Petition No. 1768

- (X) Involved; have no objection to request for encroachment at various locations on 1400 Woodward (With Outdoor Seating, Planters, Exterior Lighting, Hotel Entrance Awnings, Other Awnings and Encroachments) as shown on drawing no. X 1768 dated 04/05/2018 and revised 10/2/2018 provided that the following conditions are met with:

REQUEST ENCROACHMENT
 VARIOUS LOCATIONS
 AT 1400 WOODWARD
 (With Outdoor Seating, Planters, Exterior Lighting
 Hotel Entrance Awnings, Other Awnings
 and Encroachments)

CITY OF DETROIT	
CITY ENGINEERING DEPARTMENT	
SURVEY BUREAU	
JOB NO.	01-01
DRWG. NO.	X 1768

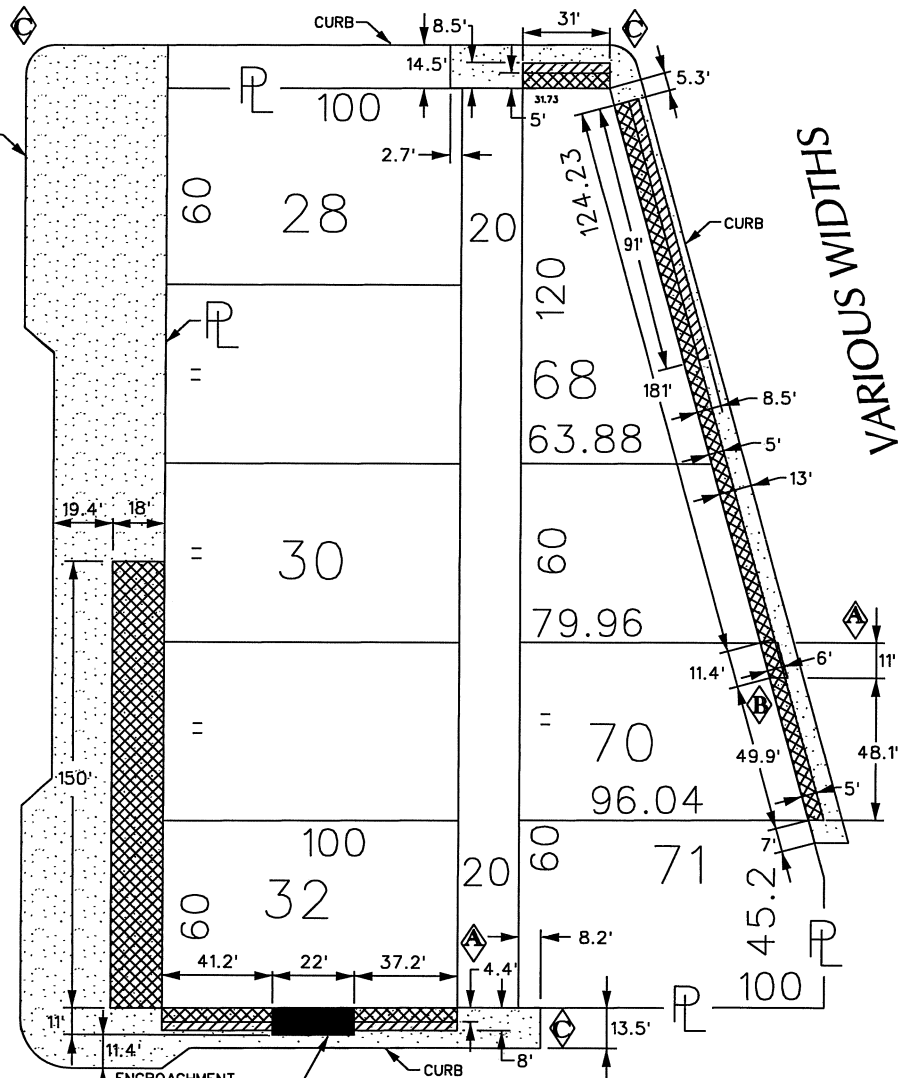
- (1) Petitioner is responsible for providing for a minimum of 6 feet clear unobstructed sidewalks in front of proposed encroachment.
 - (2) Petitioner shall maintain a minimum clear height of 8 feet and 10 feet respectively from the ground/sidewalk level to underneath the proposed aerial encroachments as shown on drawing no. X 1768 dated 04/05/2018 and revised 10/2/2018
